Access Compliance Report Public Rights-of-Way (Curb Ramps)

Intersection ID: 43493Main Street:BIRCHFIELD_CTCross Street:CHESLEY_DRLocation:NEADA ID: A5569FB017F3Ramp Type:BlendTrans1Initial Pass/Fail:FailOverall Compliance:NoSeverity Score:10

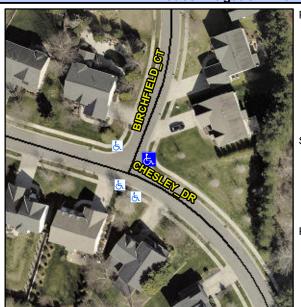
Not Found, R304.5.1, R304.5.3

Compliance Description		Data	Compliance Description		Data
	N/A	Ramp Length (in)	48.0	Yes	BlendTrans Slope (%)	4.8
	No	Ramp Width (in)	41.0	No	BlendTrans XSlope (%)	4.4
	N/A	Flare Type LT	N/A	N/A	Flare Type RT	N/A
	N/A	Flare Slope LT (%)	N/A	N/A	Flare Slope RT (%)	N/A
	N/A	Flare Traversable LT?	N/A	N/A	Flare Traversable RT?	N/A
	N/A	Landing Length (in)	N/A	N/A	DWS Provided?	N/A
	N/A	Landing Width (in)	N/A	N/A	DWS Contrast?	N/A
	N/A	Landing Slope (%)	N/A	N/A	DWS Length (in)	N/A
	N/A	Landing X Slope (%)	N/A	N/A	DWS Full Width?	N/A
	N/A	Landing Curb? (Y/N)	N/A	N/A	DWS Offset (in)	N/A
	N/A	Shared Landing?	N/A			
	N/A	Gutter Ponding?	N/A	N/A	Gutter Slope (%)	N/A
	N/A	Gutter Lip Ht (in)	1.5	N/A	Gutter X Slope (%)	N/A
	N/A	Painted X Walk1?	No	N/A	Painted X Walk2?	No
		X Walk 1 Direction	To NW		X Walk 2 Direction	To S
		X Walk 1 Width (in)	N/A		X Walk 2 Width (in)	N/A
		X Walk 1 Slope (%)	8.3		X Walk 2 Slope (%)	3.6

Remove & Replace Curb Ramp With
Two New Directional Ramps or
Equivalent.
